Access Compliance Report

Intersection ID: 53096	Main Street: BRODIE_LN	Cross Street: DIXIE_RIVER_RD	Location: SE
ADA ID: 154C1BB528F6	Ramp Type: PerpDiag	Initial Pass/Fail: Fail	Overall Compliance: No
Severity Score: 8.75			
Codes/Mitigation Info/Possible Solution		Field Measurements/Component Compliance

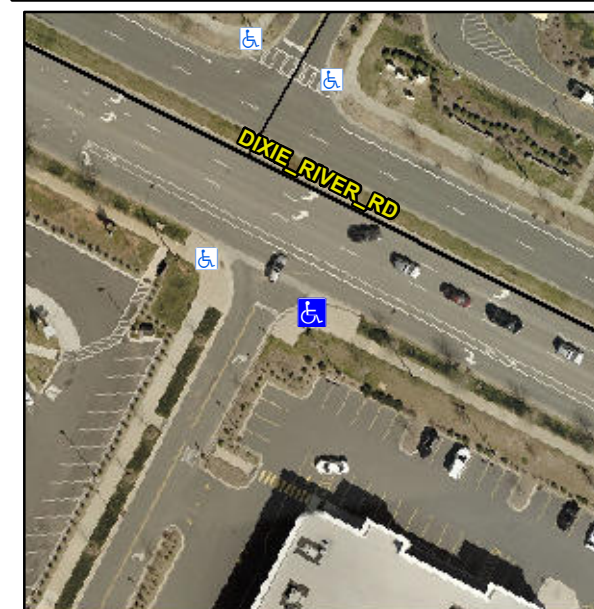
Not Found, R304.5.1

Compliance	Description	Data	Compliance	Description	Data
N/A	Ramp Length (in)	65.0	Yes	Ramp Slope (%)	6.9
No	Ramp Width (in)	47.0	Yes	Ramp XSlope (%)	1.2
N/A	Flare Type LT	N/A	N/A	Flare Type RT	N/A
N/A	Flare Slope LT (%)	N/A	N/A	Flare Slope RT (%)	N/A
N/A	Flare Traversable LT?	N/A	N/A	Flare Traversable RT?	N/A
N/A	Landing Length (in)	N/A	N/A	DWS Provided?	N/A
N/A	Landing Width (in)	N/A	N/A	DWS Contrast?	N/A
N/A	Landing Slope (%)	N/A	N/A	DWS Length (in)	N/A
N/A	Landing X Slope (%)	N/A	N/A	DWS Full Width?	N/A
N/A	Landing Curb? (Y/N)	N/A	N/A	DWS Offset (in)	N/A
N/A	Shared Landing?	N/A			
N/A	Gutter Ponding?	N/A	N/A	Gutter Slope (%)	N/A
N/A	Gutter Lip Ht (in)	N/A	N/A	Gutter X Slope (%)	N/A
N/A	Painted X Walk1?	No	N/A	Painted X Walk2?	No
	X Walk 1 Direction	To NE		X Walk 2 Direction	To NW
N/A	X Walk 1 Width (in)	N/A	N/A	X Walk 2 Width (in)	N/A
	X Walk 1 Slope (%)	5.7		X Walk 2 Slope (%)	2.7
	X Walk 1 X Slope (%)	0.6		X Walk 2 X Slope (%)	5.8

Remove & Replace Curb Ramp With Two New Directional Ramps or Equivalent.
